Project No. 21482114

**RESPONSE TO GEOTECHNICAL PEER REVIEW COMMENTS FROM GEMTEC
PROPOSED RESIDENTIAL DEVELOPMENT
3930 AND 3960 RIVERSIDE DRIVE, OTTAWA, ONTARIO**

A geotechnical peer review was completed by GEMTEC on behalf of the City of Ottawa and the relevant comments were provided in GEMTEC Letter no. 100008.025 – Rev0, dated Dec 7, 2023. The comments are noted below with response from WSP.

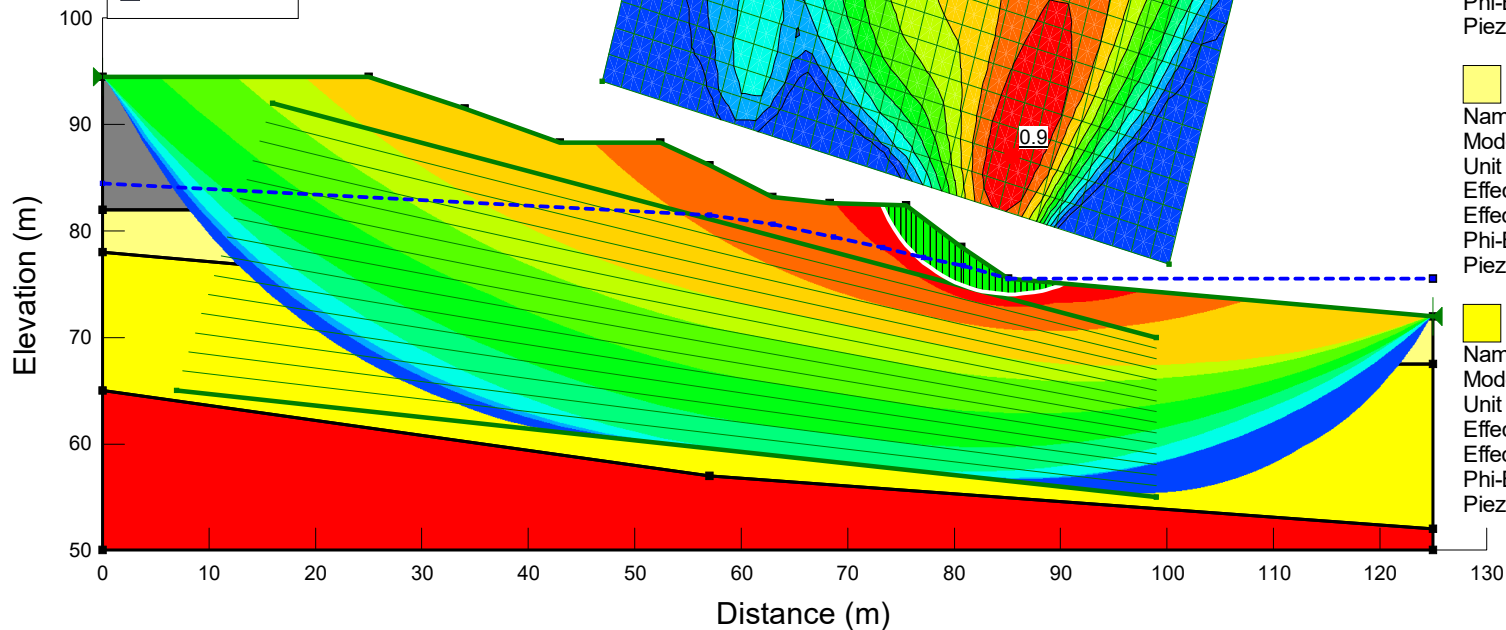
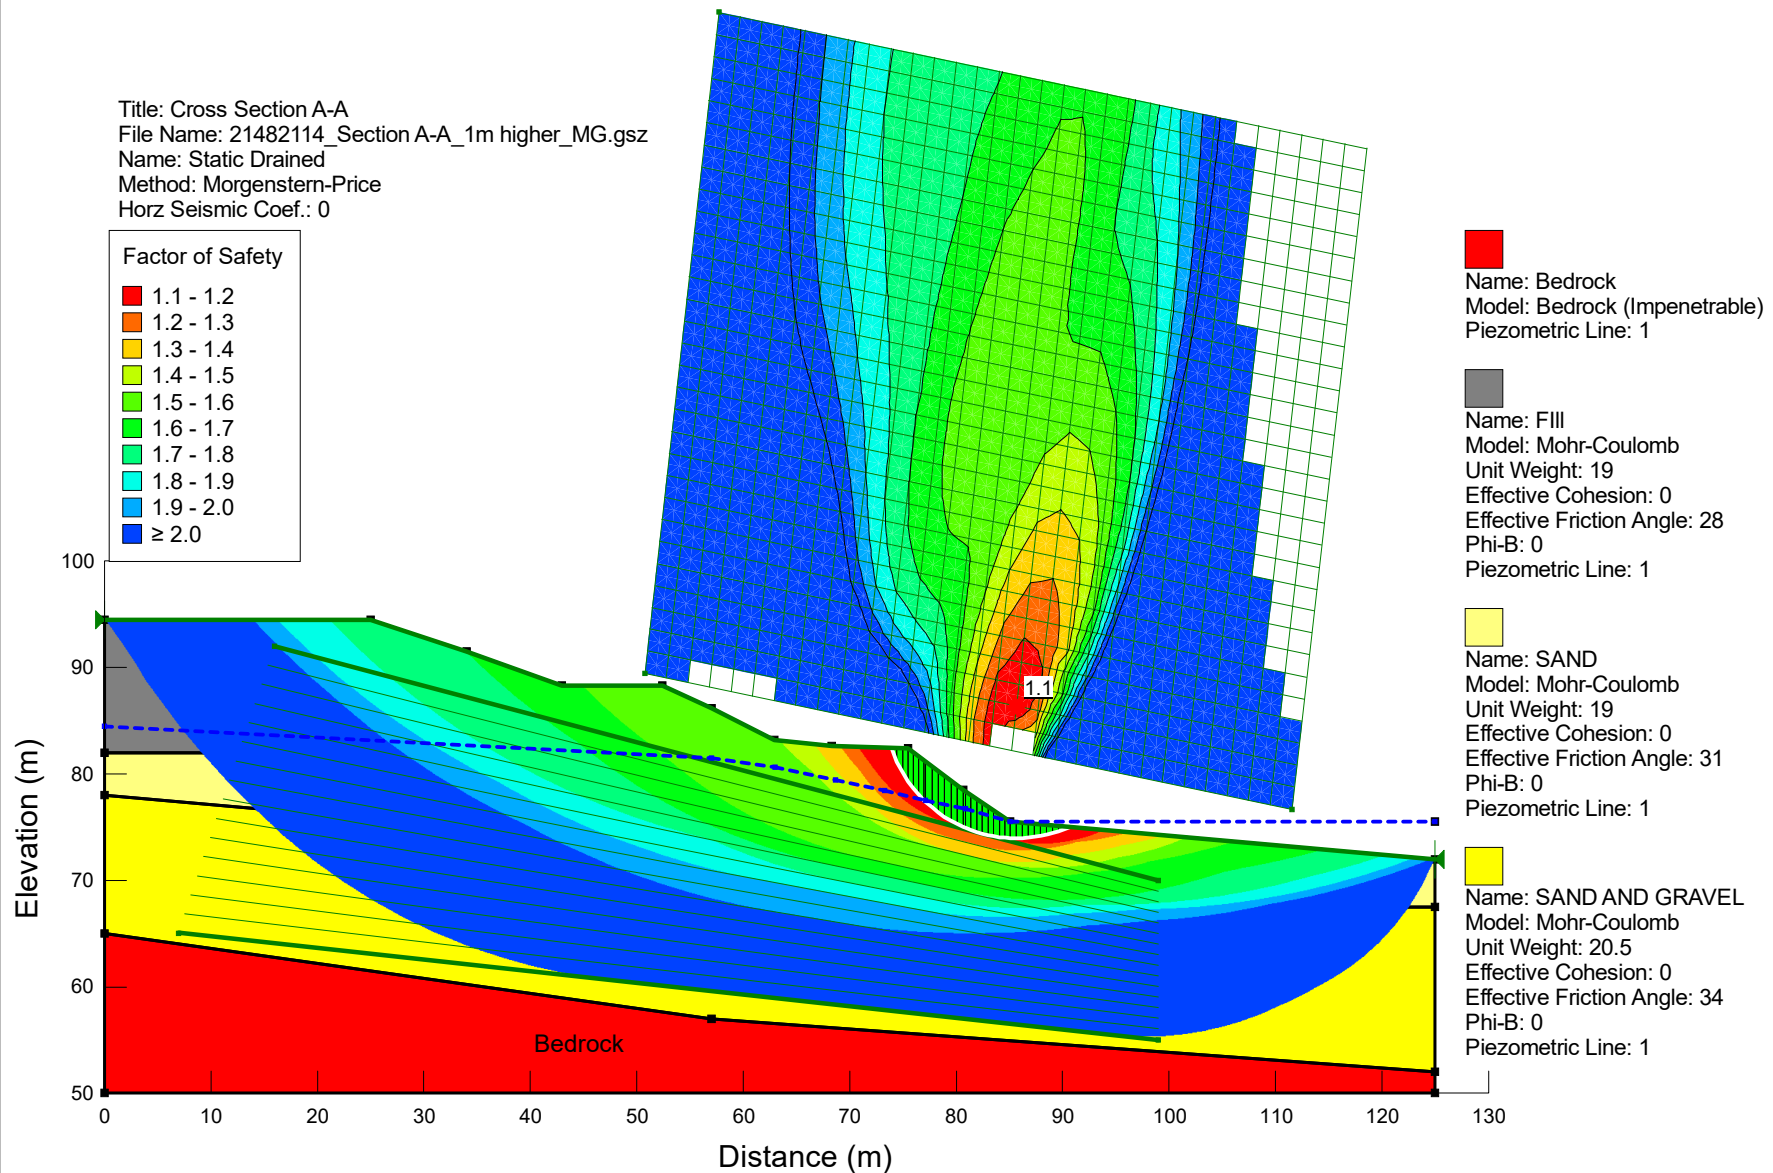
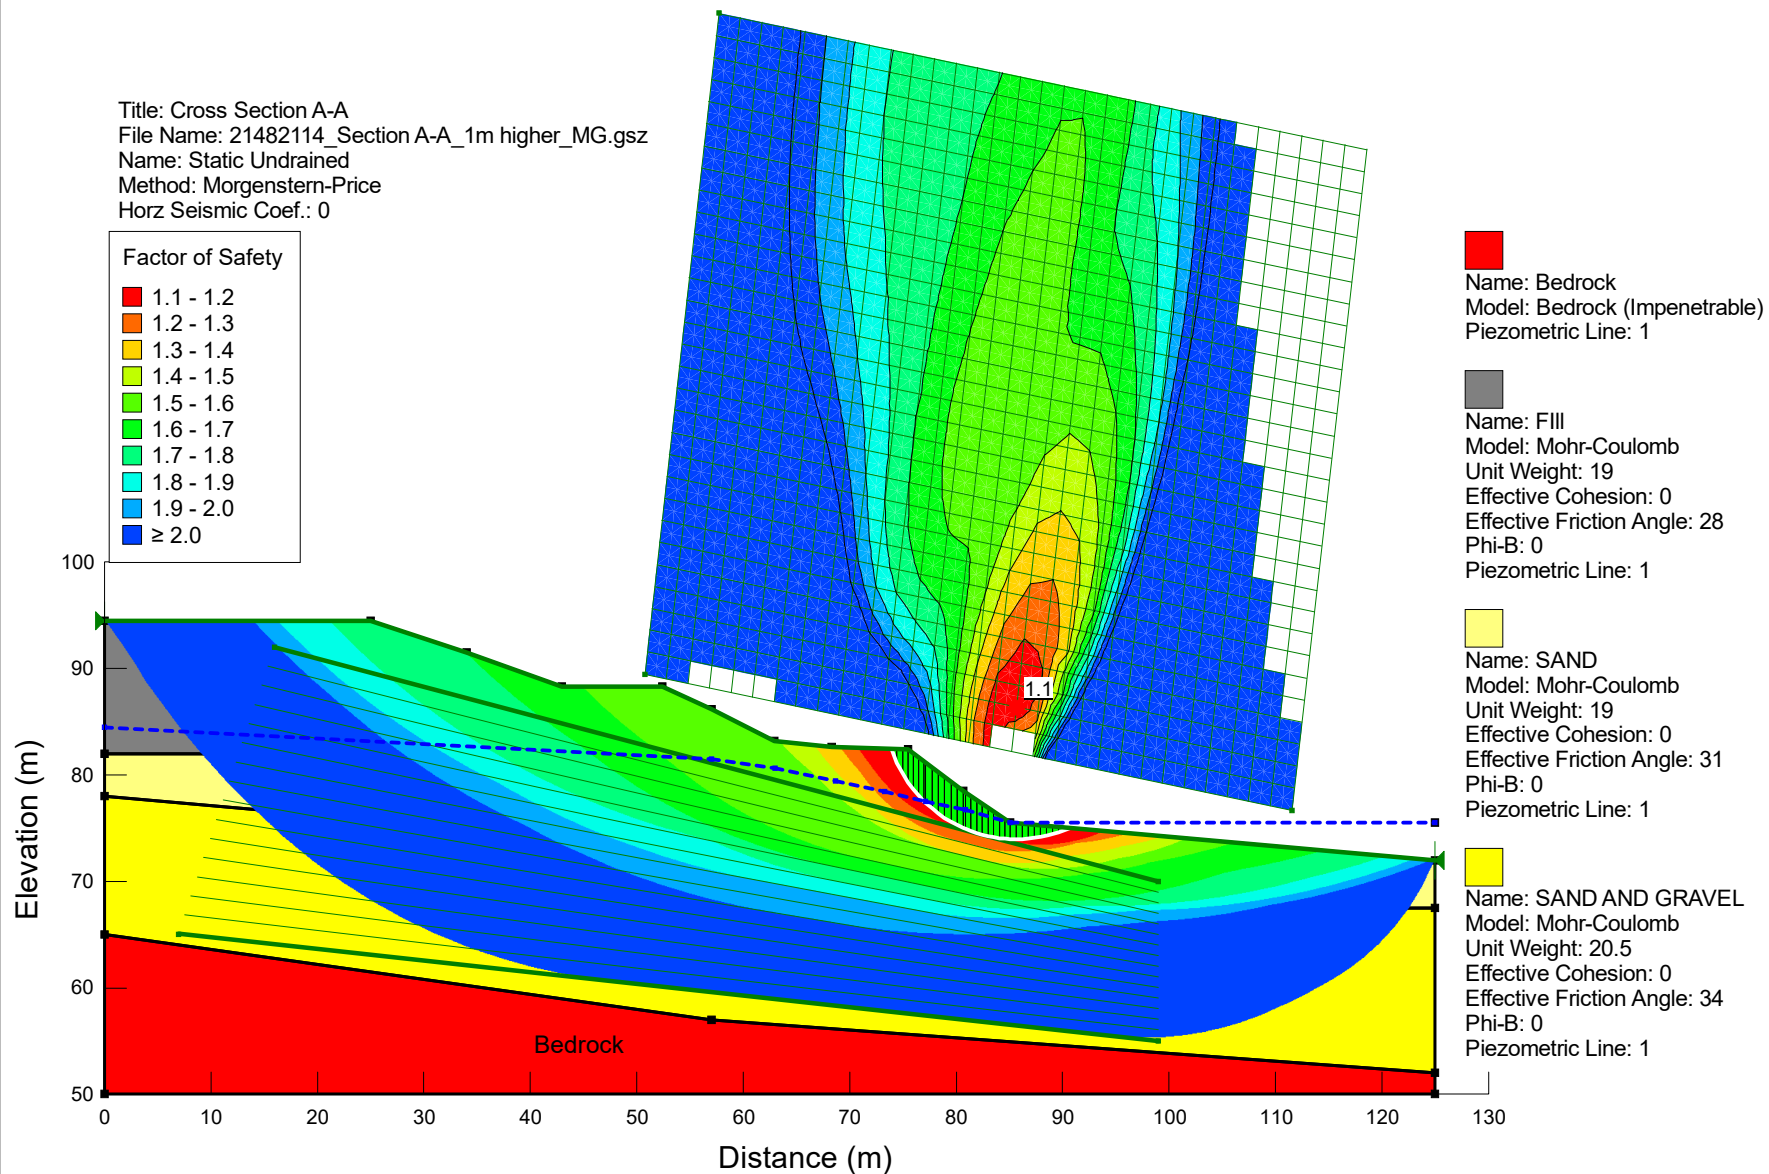
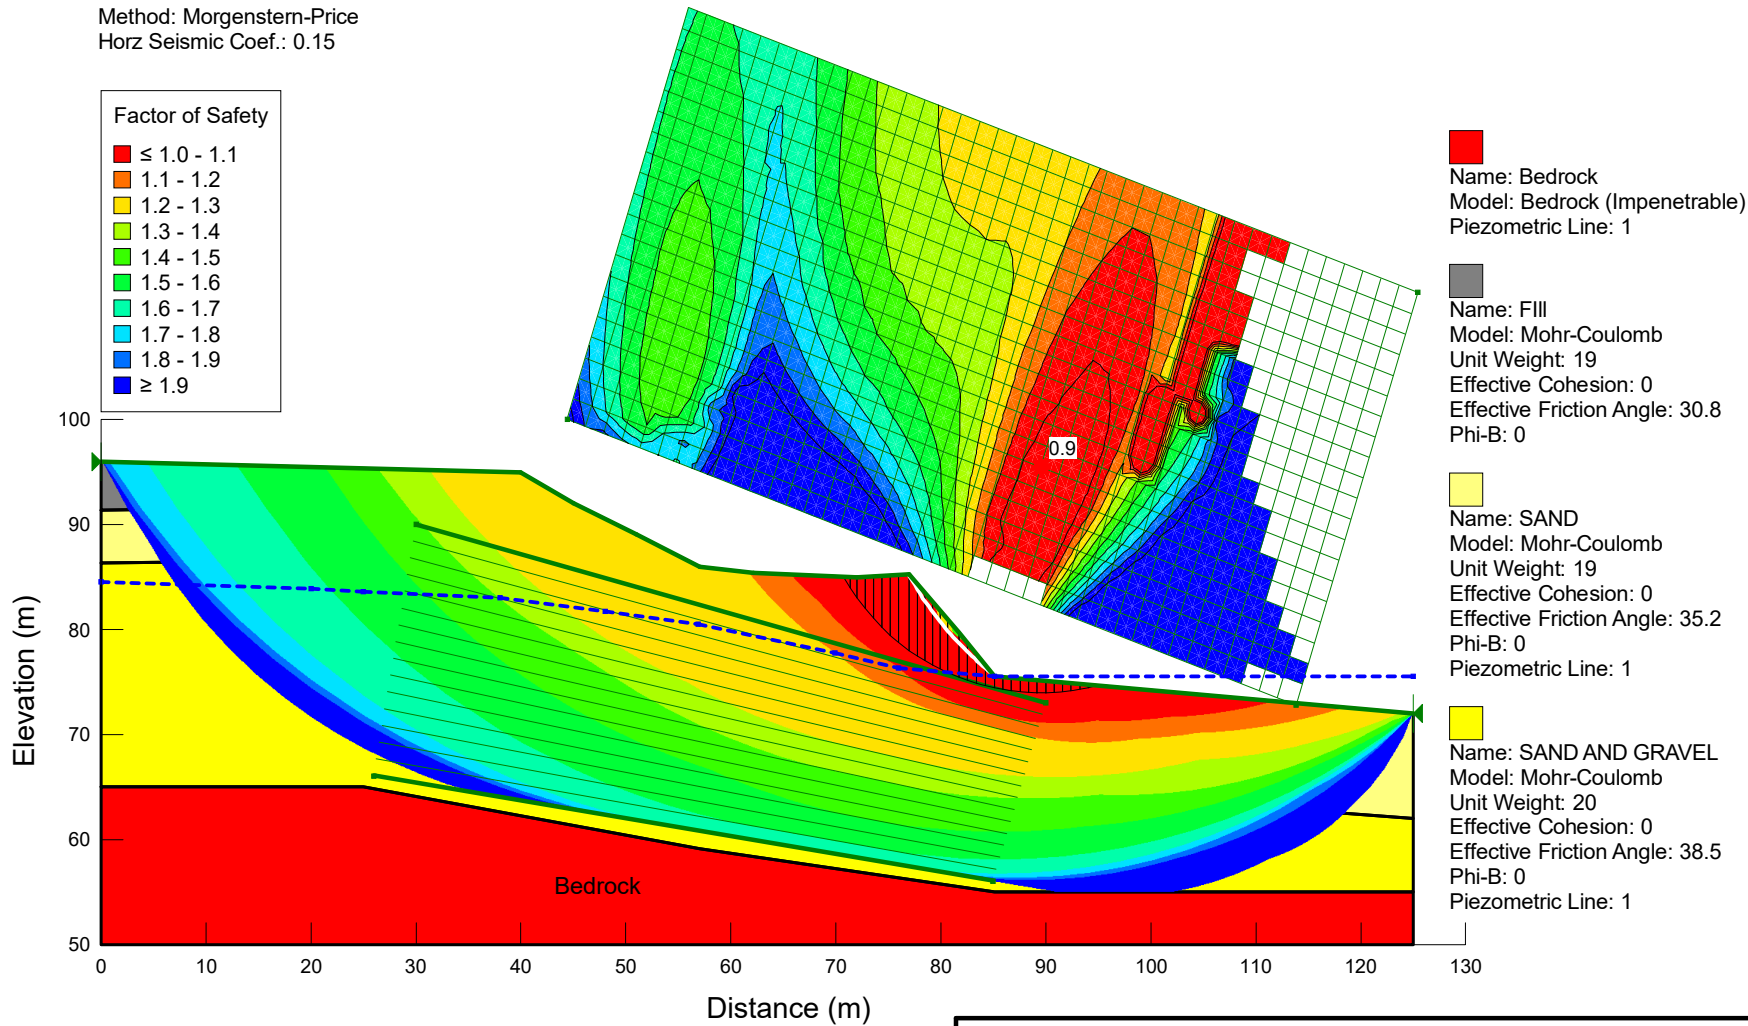
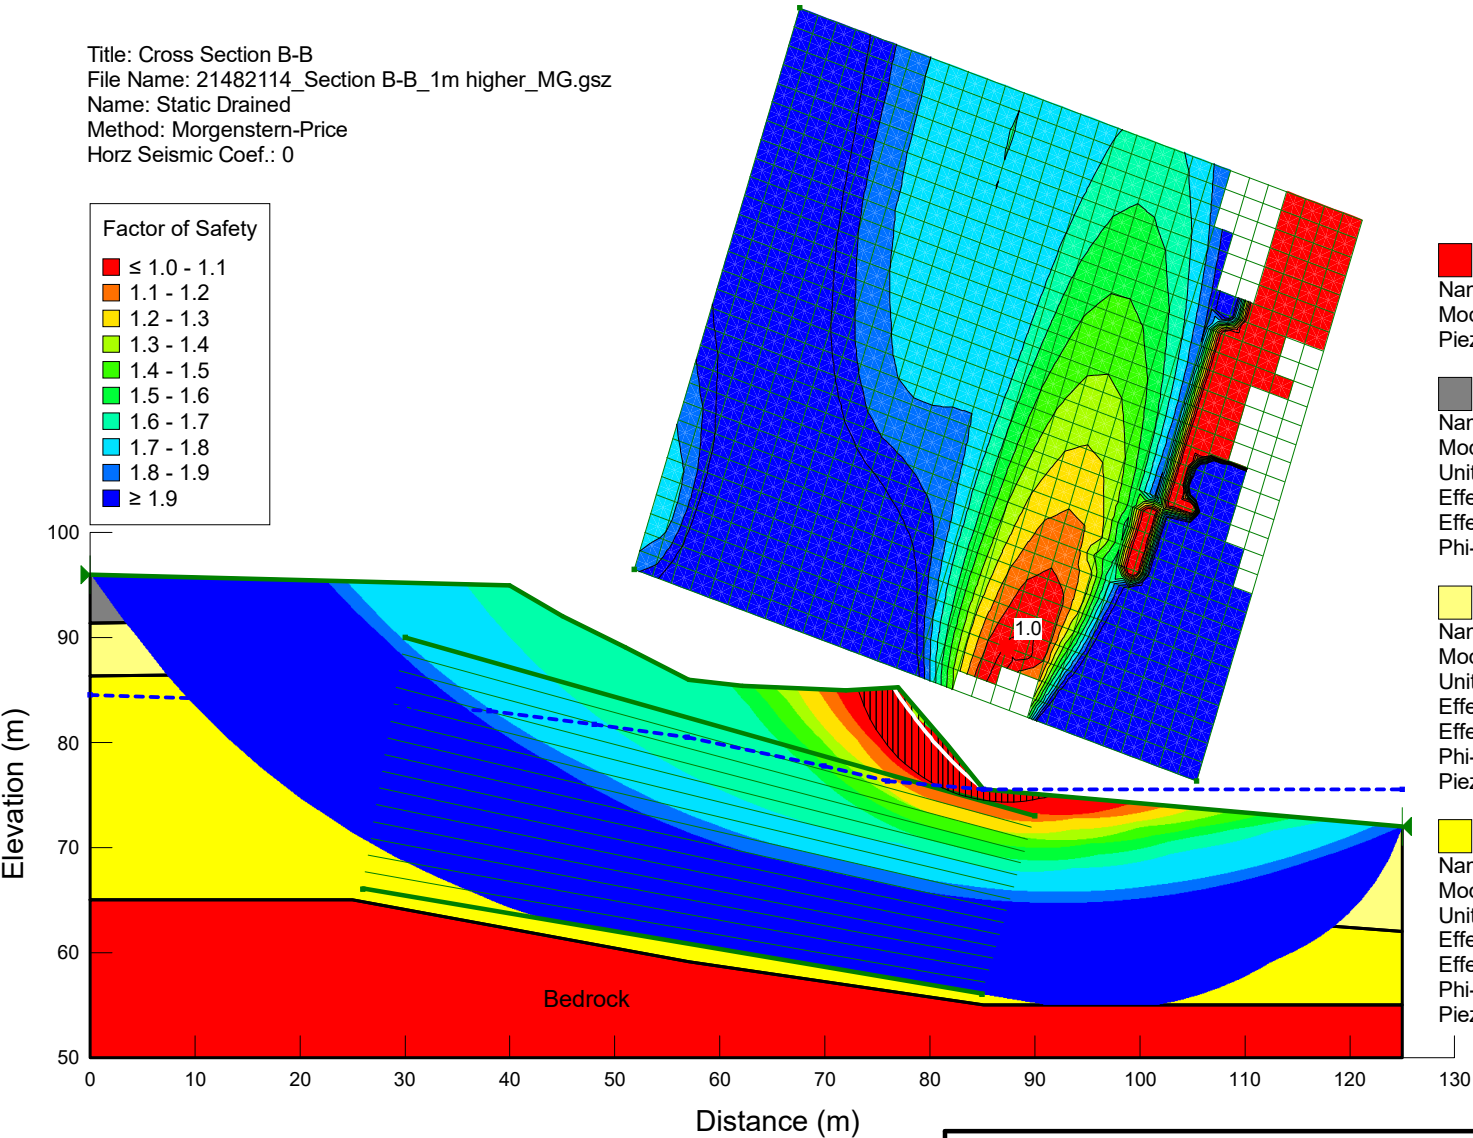
- 4) “The following comments are provided for the slope stability analysis carried out for Sections A-A', B-B', C-C', and D-D'. The safety map for the static and seismic analyses for the values of less than 1.5 and 1.1 respectively, extends past the upper edge of the point grid (for the slip circle centre), which may indicate there are slip circles with those factors of safety or less that extend horizontally farther than currently shown. This could potentially result in an increased stable slope allowance, and it is suggested that the model geometry be revised (by extending the point grid) to check the limits.”

- 5) “The groundwater level assumed in the static analyses for the South Area is at the base of the existing fill (i.e., at elevations of about 82 to 83 m) and is indicated to be based on the water levels measured in the various monitoring wells at the site. This would be Case 3 as outlined in the slope stability guidelines and may not be a realistic assumption. The fill materials above the native sands are not uniform in composition and contain cohesive layers and materials with high silt and clay contents that will tend to retain water and therefore it may not be reasonably conservative to assume the fill materials are fully drained as assumed in the slope stability analyses. The water levels summary in Section 4.1 of the report notes that: “In the South Area, the groundwater level was generally found to be between 12 to 16 m depth (i.e., between elevations of about 75 to 83 m), but as shallow as about 6 m (i.e., elevation of about 88 m).”

Response – *The models for the sections identified above were revised (by extending the point grid), no differences have been observed in the stable slope allowance.*

Response – *While the water level in the south area was recorded to be between elevations of 75.1 and 87.6 m (in monitoring wells as well as from CPT Dissipation testing), it was generally found to be below elevation of 79 m. Only one single borehole location had a higher water level of 87.6. We therefore feel that the original assumptions regarding groundwater level are reasonable assumptions for the overall groundwater depth in the area of interest. Nonetheless, as a precautionary measure and an additional check, the slope stability models for these four sections were revised to take into account for the possibility of a higher groundwater level in South Area by adjusting the piezometric line in the analysis upward in the east side of the site (where the single high level was recorded). This adjustment results in a very minor change to the slope stability (well within the margin of error of the data and assumptions which go into the analysis). The change is of sufficiently small magnitude as to make no meaningful difference to recommended stable slope allowance, and therefore we feel that the originally recommended setbacks may be maintained. The results of the revised slope stability analysis are attached to this memorandum.*
